# Memorandum

To: Planning Commission Members  
From: Elizabeth J Corwin, PE, AIPC; Planning Director  
Date: May 21, 2026  
Re: SPR25-001  
Applicant: Steve Kolber/Kolbrook Design. Owner: OM Group  
140 W Highland Road  
PIN 11-22-301-007

You are asked to review a plan amendment for the Jimmy John/Dunkin site that was previously approved in February, 2026. As the applicant was finishing up gathering final approvals, he discovered that the Oakland County Health Division could not approve the location of the septic system because the site was within the isolation distance of the neighbor's well.

SHEET NO.  
**SP1.0**

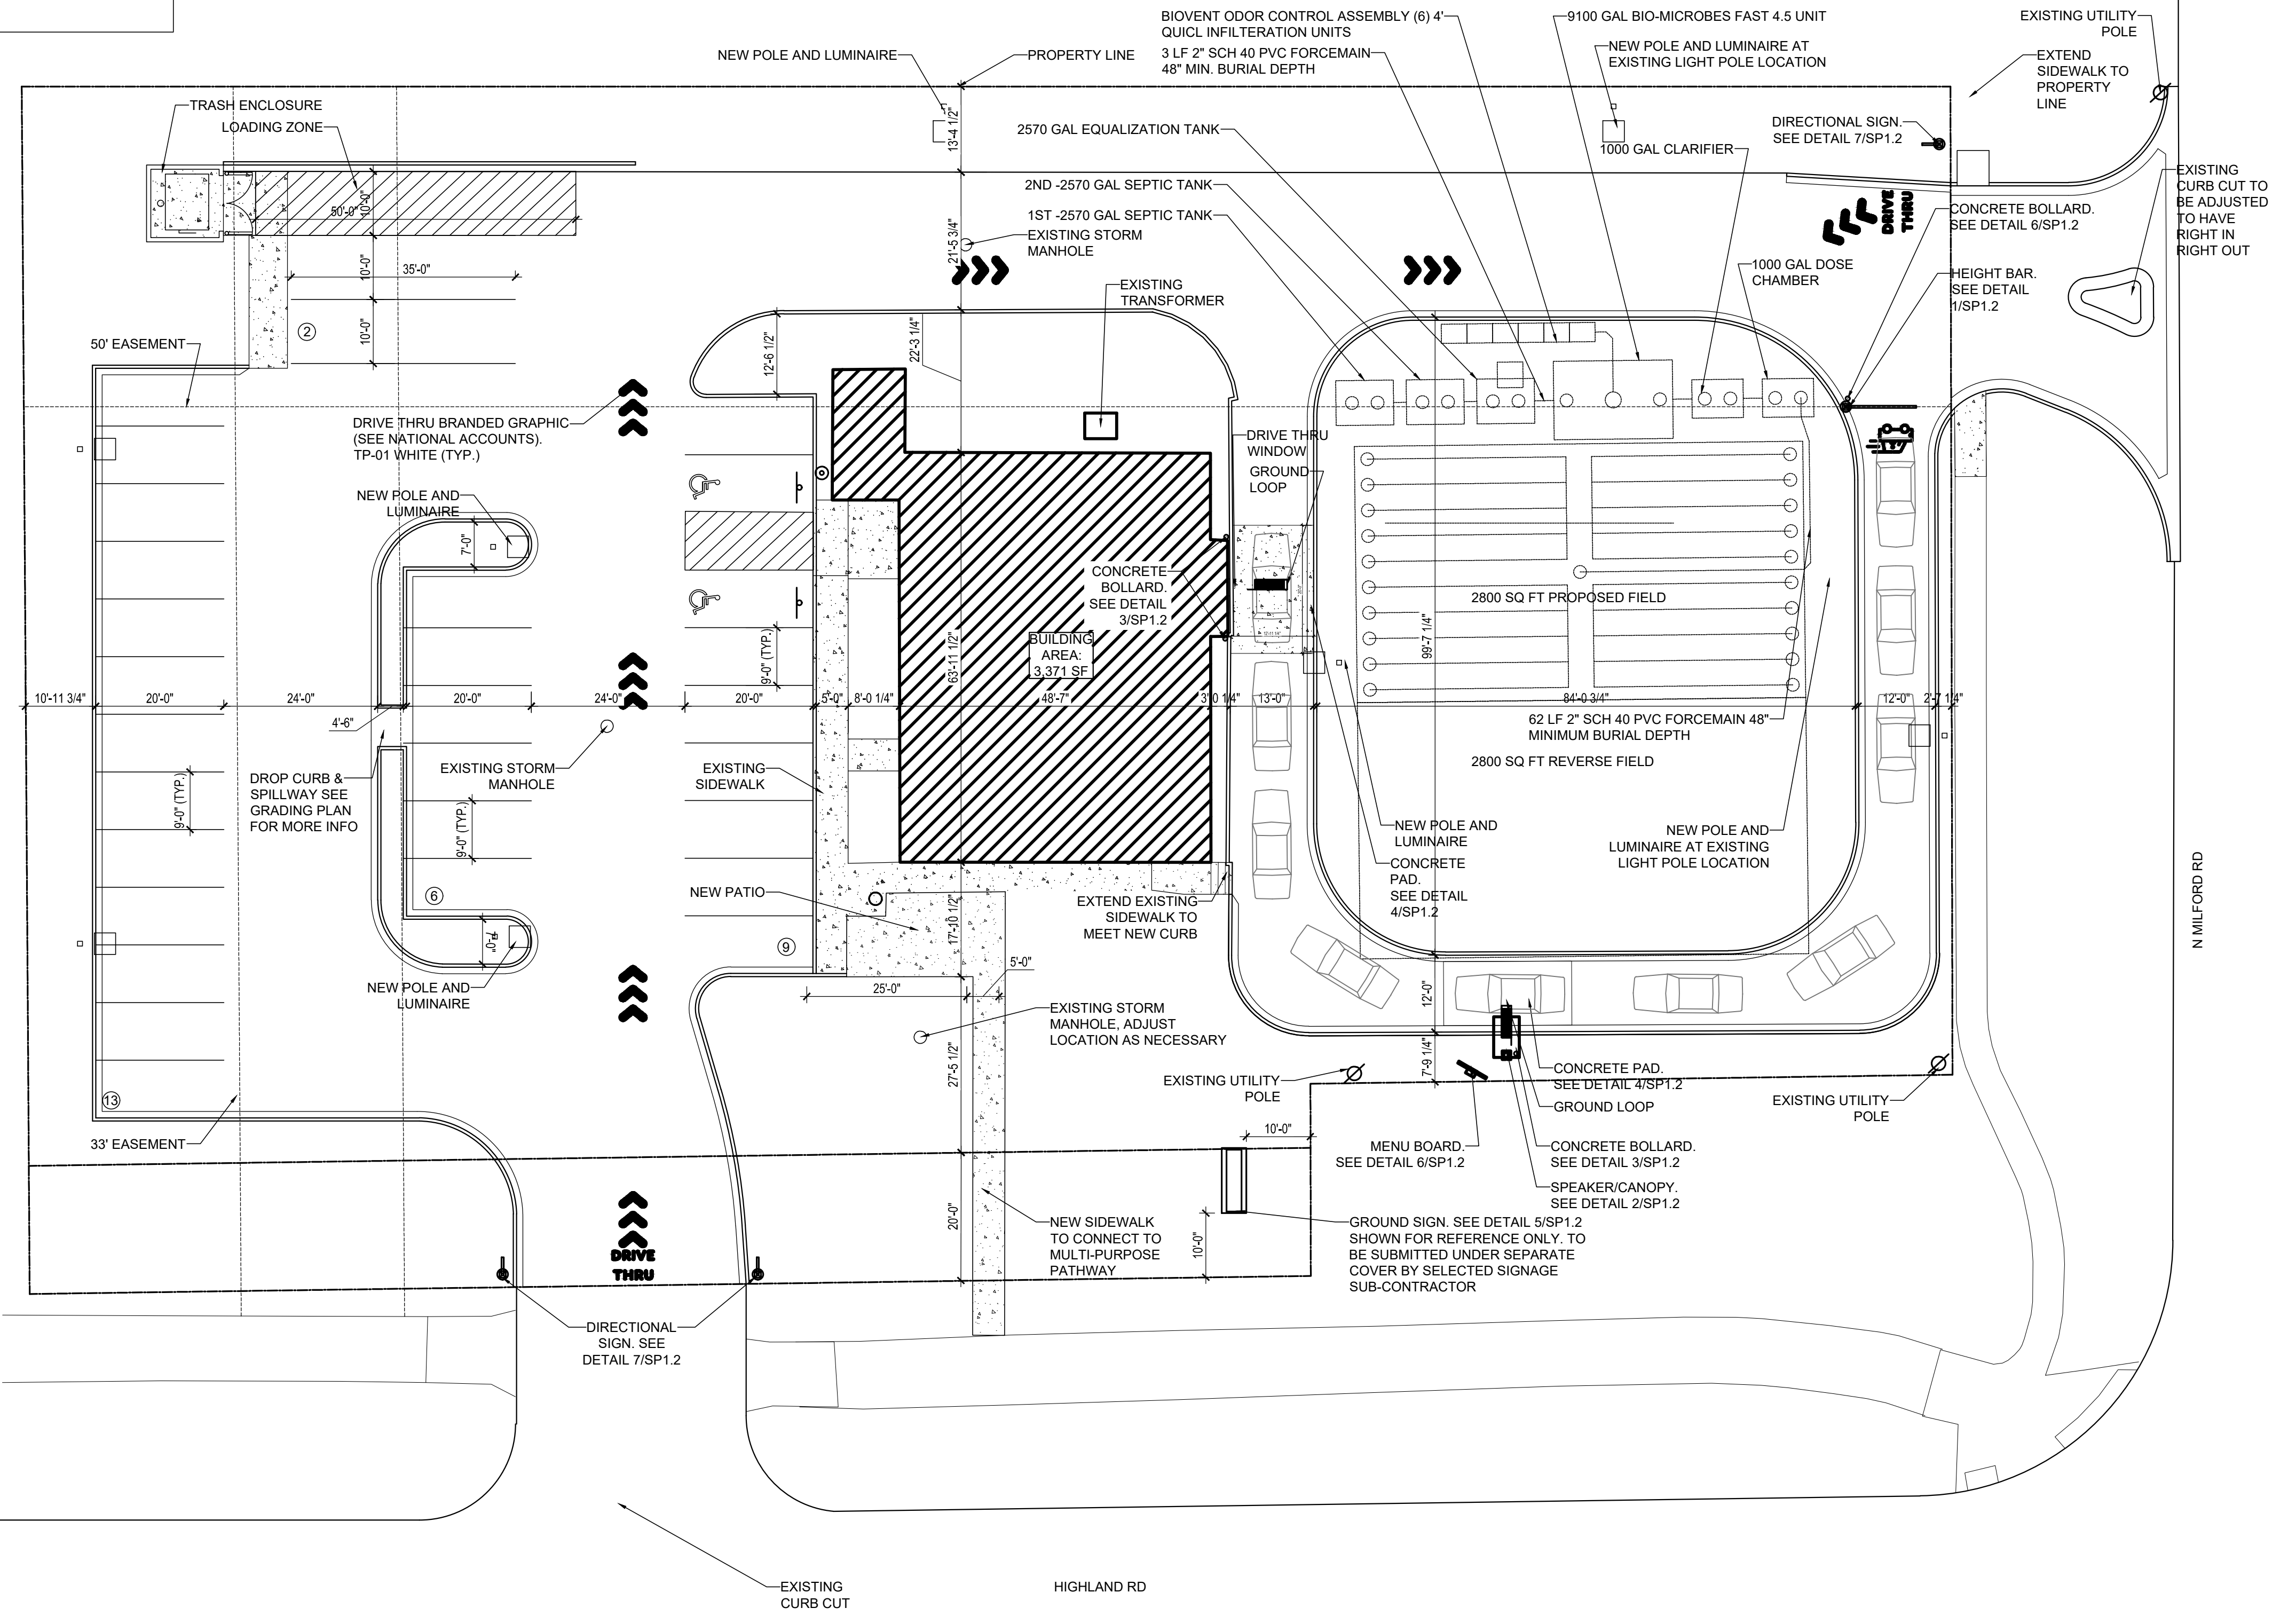
The solution proposed by the applicant is to displace the parking spaces originally proposed within the drive-through loop and place the septic system there. The displaced parking will be constructed on the west side of the site. This necessitates a reconfiguration of the site lighting and the addition of new landscaping. The applicant has used the same design approach for the amended site as with the already approved design. Driveway approaches and the traffic circulation has not been significantly impacted.

The new plan picks up an additional 3 parking spaces, which helps address the possible use of the basement floor area. The designer attests that the overall impervious area has not increased, but will be required to verify that the modifications are acceptable to the Michigan Department of Transportation, since their storm sewer currently accepts the runoff.

For your ease in review, I have attached the minutes of your February 19, 2026 meeting here so that you need not download additional files. If you would like to review the previously approved plan, the February 19 meeting packet is still online for you to compare and contrast the plans. I believe at this time the plans have addressed all previous review comments. It would be appropriate to approve the site plan conditioned upon receipt of final staff and engineering review.
